City of West Linn
PRE-APPLICATION CONFERENCE MEETING
Notes
December 15, 2011

SUBJECT: Class I Design Review for the installation of cart corrals, pedestrian pathways, new lighting, new landscaping, pallet recycling area and revised parking lot circulation at proposed Wal-Mart at 19133 Willamette Drive.

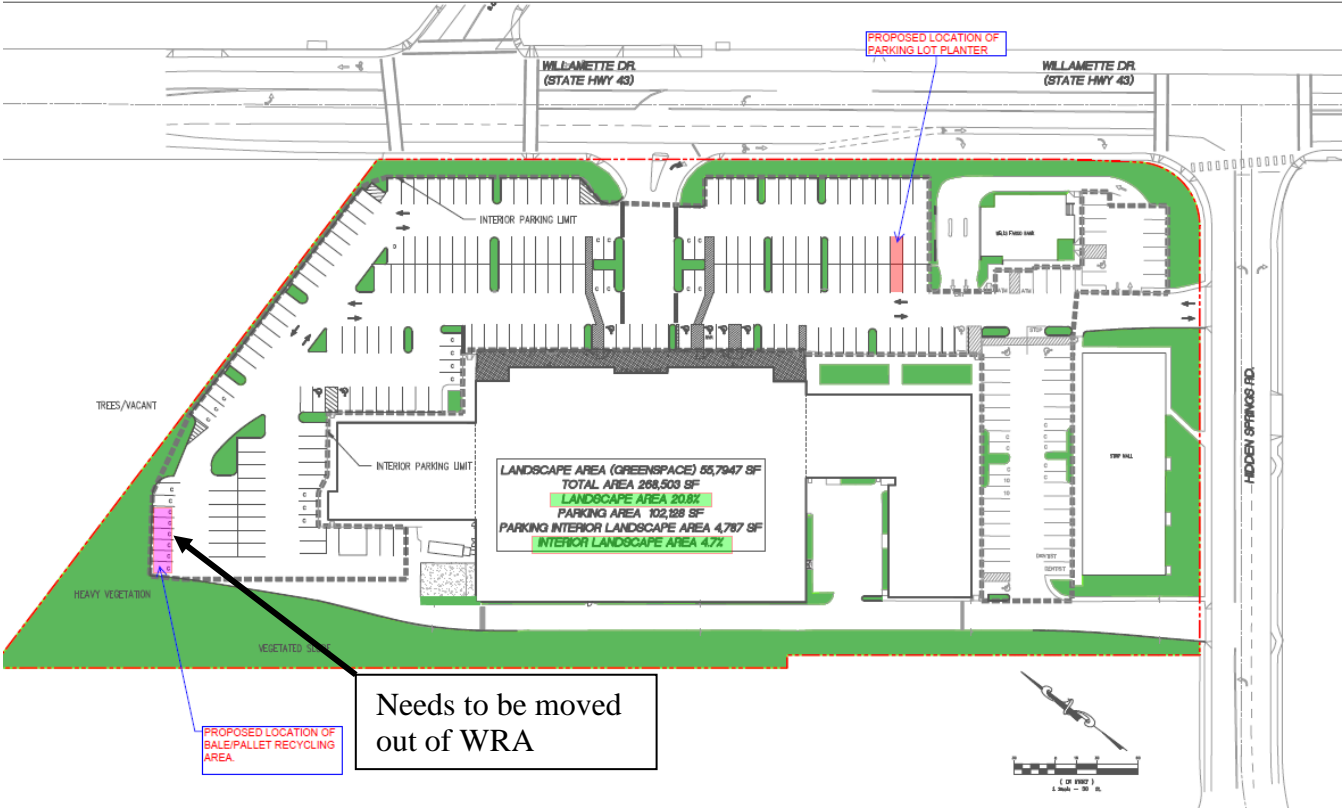
1. The interior of the parking lot is supposed to comprise 10% landscaping, typically in the form of landscaped islands and similar planters. The parking lot has about 4.7% landscaping within its interior (excluding perimeter landscaping). This proposal will maintain the current amount of landscaping by the addition of a 20' X 5' landscape island being installed near the Wells Fargo bank. Concurrently, the applicant will be adding two new light poles in the interior landscape area for a loss of 18 square feet (assuming 3' X 3' bases) and reducing a landscape area at the northeast corner of the site by 32 square feet to install a cart corral. The landscape addition and reduction will cancel each other out. No non-conforming permit is required since there will be no net decrease in parking lot interior landscaping.

2. The landscaping strip adjacent to Willamette Drive and Hidden Springs Road is required to be 15 feet wide. Although the landscaping is situated on a steep bank which tends to exaggerate the amount, it is only 10 feet wide for most of the Willamette Drive frontage. The installation of four light poles does not change the landscaped area's width so no non-conforming permit is required.

3. The parking lot is supposed to comprise a 50/50 mix of compact and full sized spaces but only 20 spaces or 7.5% of the total parking spaces are compact. The applicant will be re-striping the parking lot to add compact spaces which means that the condition will be improved so no non-conforming permit is required.

4. Pedestrian facilities are required in the parking lot per CDC 55.100(B) (7) (d). They must be eight feet wide and separated from traffic by curbs, bollards, raised surfaces, etc. No facilities exist in the parking lot so the applicant's proposal to add two pedestrian corridors improves the non-conformity. No CDC Chapter 66 permit is required.

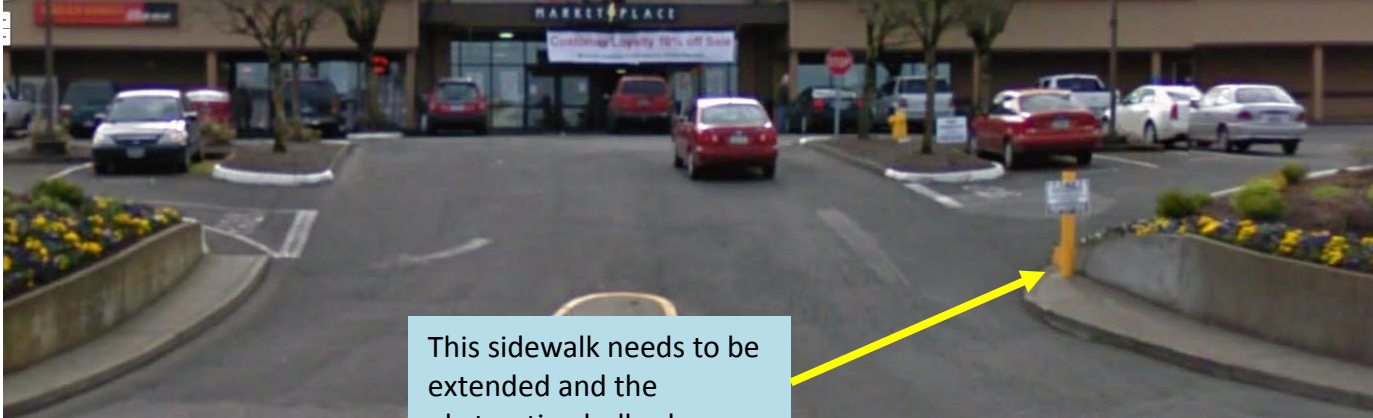
Lighting is another issue. Staff is concerned that the larger new light poles will generate off-site glare, especially the one at the north end of the service driveway. The applicant stated that the lights are intended to improve security and defensible space in the parking areas and in the building perimeter. Lights will be screened to prevent glare from being directed towards adjacent homes. Lights should be LED.

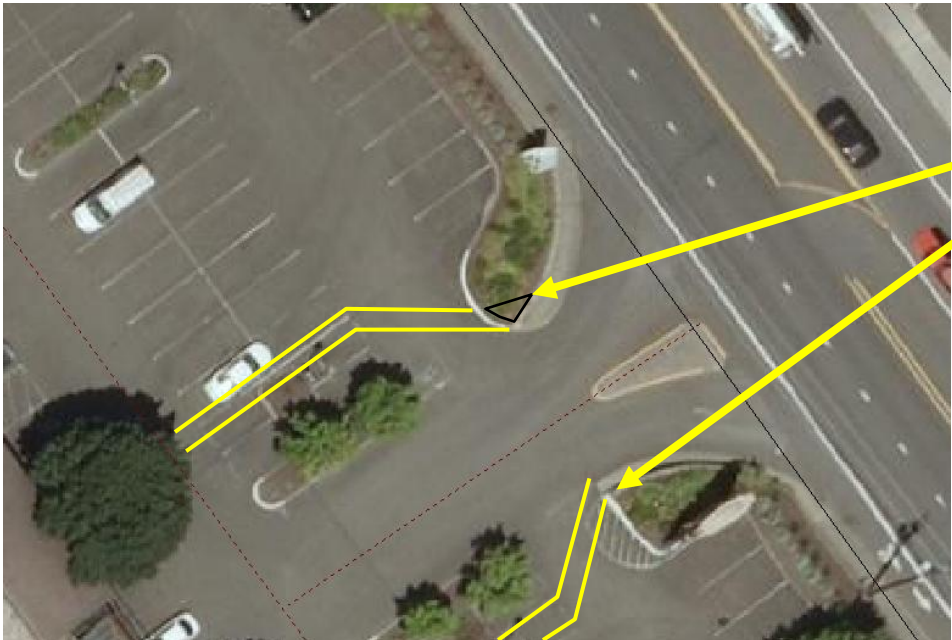
Although the creation of pedestrian facilities through the parking lot is overdue, the applicant cannot be compelled by the CDC to make those improvements. Still, the City would encourage the applicant to extend pedestrian facilities/sidewalks from the building to adjacent ROWs. For example, the sidewalk on the north driveway accessing Willamette Drive should be widened at the top. It presently narrows and terminates with a bollard which forces pedestrians into the path of traffic.

This sidewalk needs to be extended and the obstructing bollard removed.

Cutting the retaining wall back and creating a proper pedestrian approach and refuge area would better meet the design review criteria
